PLAN COMMISSION/HISTORIC PRESERVATION COMMISSION WEDNESDAY, FEBRUARY 26, 2020

February 21, 2020

To: Village of Mount Horeb Plan Commission
From: Village Planner Michael A. Slavney, FAICP
Date: February 25, 2020
Re: Specific Implementation Plan and Design Review for Proposed Sienna Hills Homes, Two-Family Planned Development

FRONT ELEV

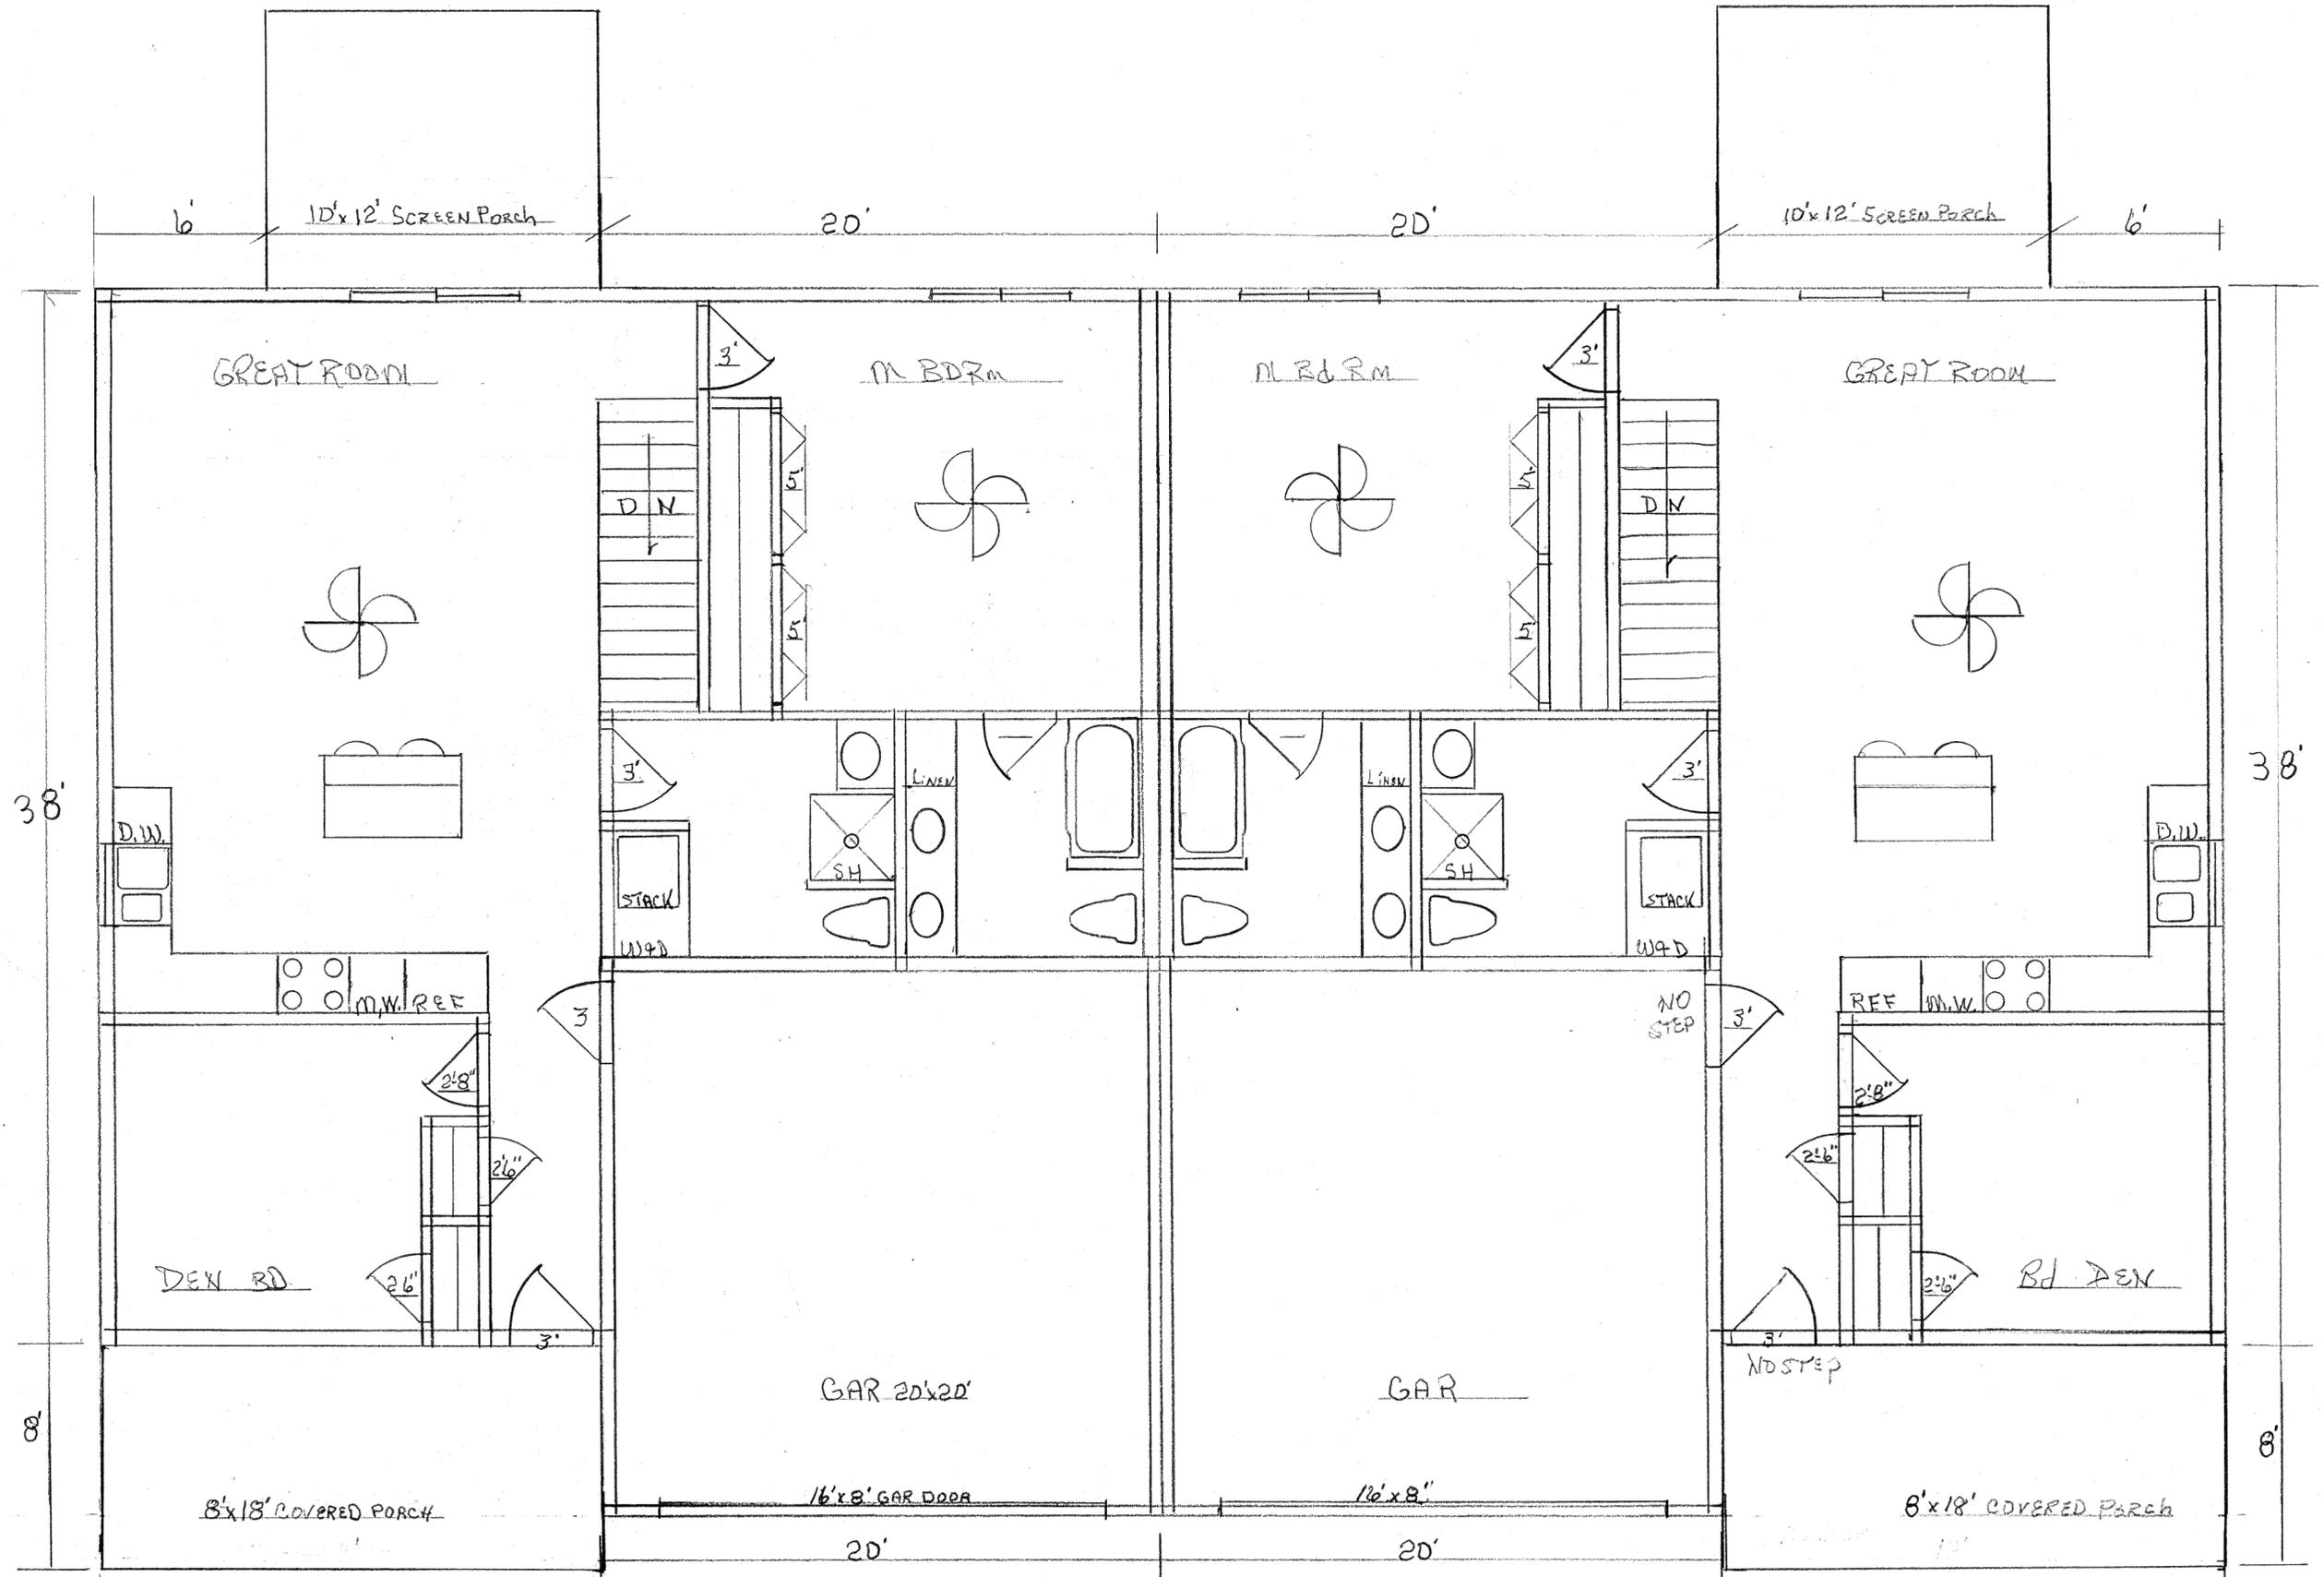
- a. Long building facades shall be visually broken up and variegated with staggers and offsets as determined appropriate by the Plan Commission.
 - *The Plan Commission should discuss this. Is the single large gable over the dual two-car garage front wall acceptable? Many similar two-unit buildings employ a staggered double gable to create a smaller gable and avoid the large triangle facing forward.*
 - *Secondly, for the buildings backing up to Eastwood Way, I believe a more attractive rear elevation should be provided, or alternatively, a relatively dense low hedge located about ten feet south of the Eastwood Way right-of-way to provide a more private backyard.*

- *The Plan Commission should discuss this. This requirement may be considered met on all portions of the building using the mid-pitched gable roof – similar to surrounding buildings. Would the Plan Commission like to require a double gable roof form over the garage doors?*

- Design Requirement 6.a.: Waive the requirement to comply with requirements for Large Developments.
 - Design Requirement 7.a.1.: Consider whether the front of each unit is sufficiently articulated. Is the requirement met, waived, or does the front of each unit require a modification?
